Documentation and plans for 95 East 14th Avenue related to Building Permits BP-2018-05371 and BP-2019-01801. Date range: December 1, 2018 - December 31, 2019.

From: Mahpour, Hamid
Sent: Wednesday, May 01, 2019 9:06 AM
To: Renter Office; Ellis, Sarah
Subject: 95 E 14 AV, BP-2019-01801

Permit application BP-2019-01801 is opened for renovation to the rental building at 95 E 14 Avenue. Included in the renovation is changes to layout of the units and replacement of exterior windows. BP-2018-05371 was also issued in December 2018 for re-piping of the said building.

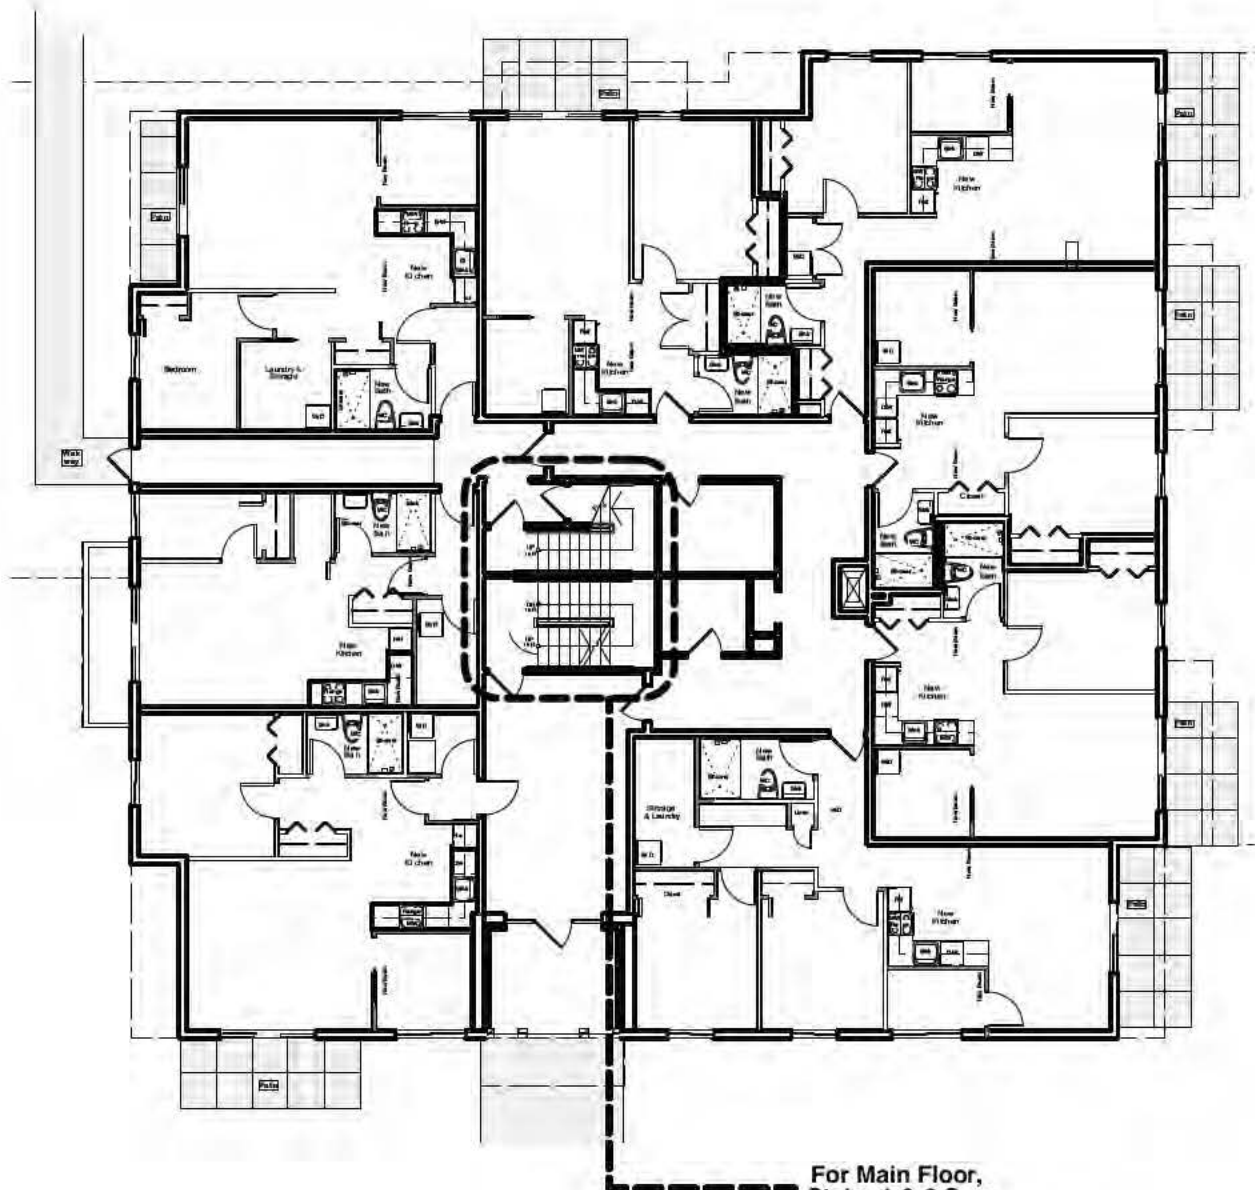
a. Provide exit stair details demonstrating compliance with VBBL

Item 4a- Using VBBL 2019 Article 11.3.5.4 to justify compliance of the existing exit stairs with VBBL requirements is acceptable only when the Generic Alternative Solution to CBO office was accepted. Please note Bulletin 2019-005-BU and have the said Generic AL submitted to CBO office. Contact Boris Turishev of CBO at (604)873-7401 or boris.turishev@vancouver.ca for questions on Alternative Solutions.

The existing rise and run dimensions comply with VBBL2019, Table 11.3.6.9 (4)

- New slip resistant finish will be installed on treads and landings.
- New nosings with distinct colour contrast for the full width of the leading edge will be installed.
- No projecting nosing, rakeback, or combination thereof shall exceed 38mm or angle of more than 30 degrees from the vertical.
- Lighting shall comply with 11.3.6.9.(4) c); emergency lighting shall comply with 11.3.6.9.(4) d).
- New Handrails shall comply with 3.4.6.5.
- Emergency power will be provided in accordance with 3.2.6.5.

D tail Plan - Level 3 - Exit Stair
Scale: 1/4" = 1'-0"

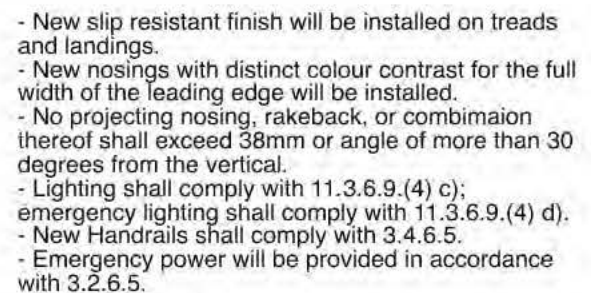
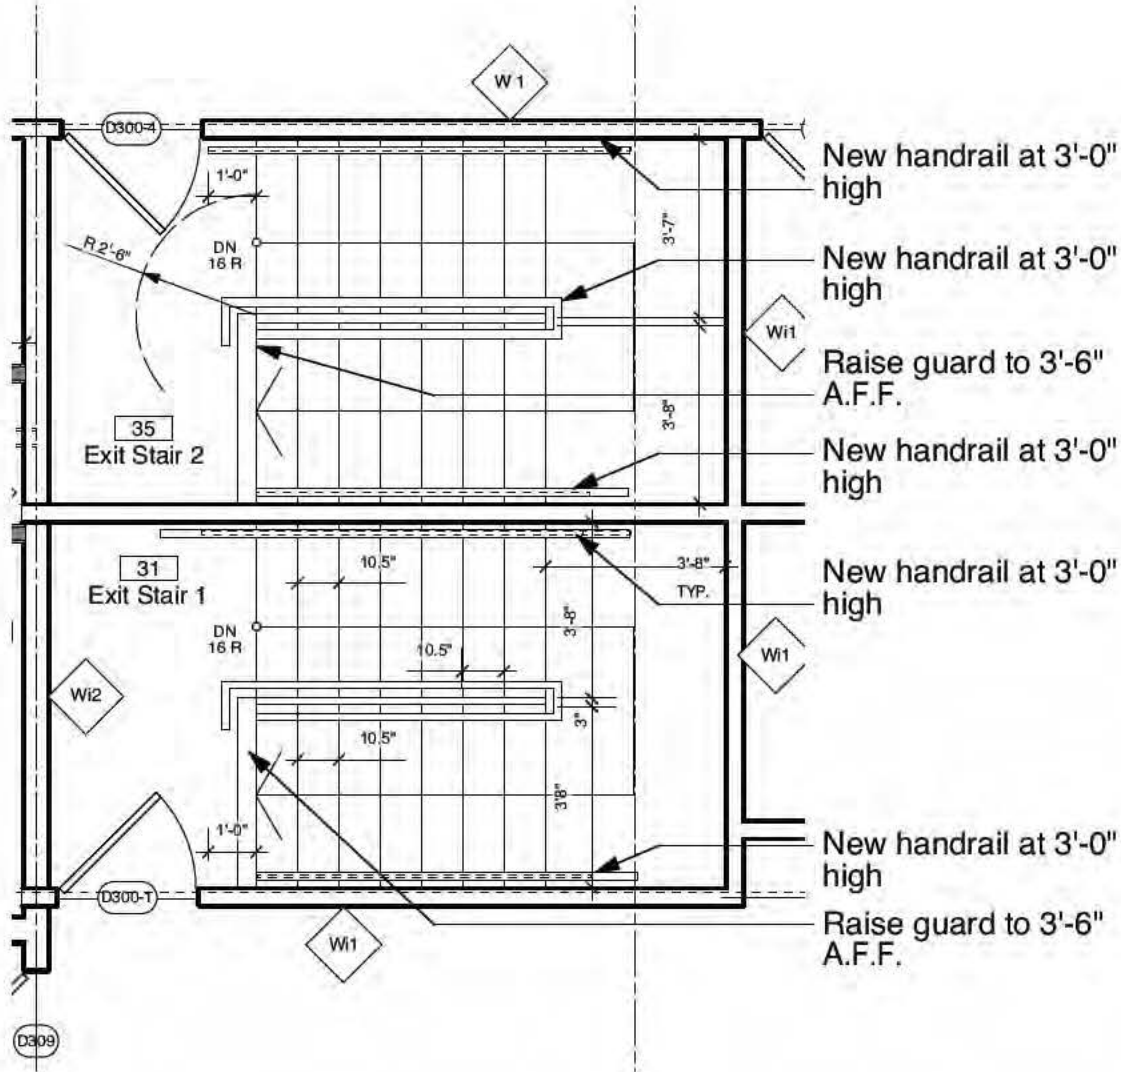
a. Provide exit stair details demonstrating compliance with VBBL → **Not provided. It is outstanding. You may be able to justify the existing noncomplying features of the building to**

- New slip resistant finish will be installed on treads and landings.
- New nosings with distinct colour contrast for the full width of the leading edge will be installed.
- No projecting nosing, rakeback, or combination thereof shall exceed 38mm or angle of more than 30 degrees from the vertical.
- Lighting shall comply with 11.3.6.9.(4) c); emergency lighting shall comply with 11.3.6.9.(4) d).
- New Handrails shall comply with 3.4.6.5.
- Emergency power will be provided in accordance with 3.2.6.5.

Notations and modifications have been provided on the drawings. Please see new drawing sheet A2.11 Vestibules & Exit Stairs.
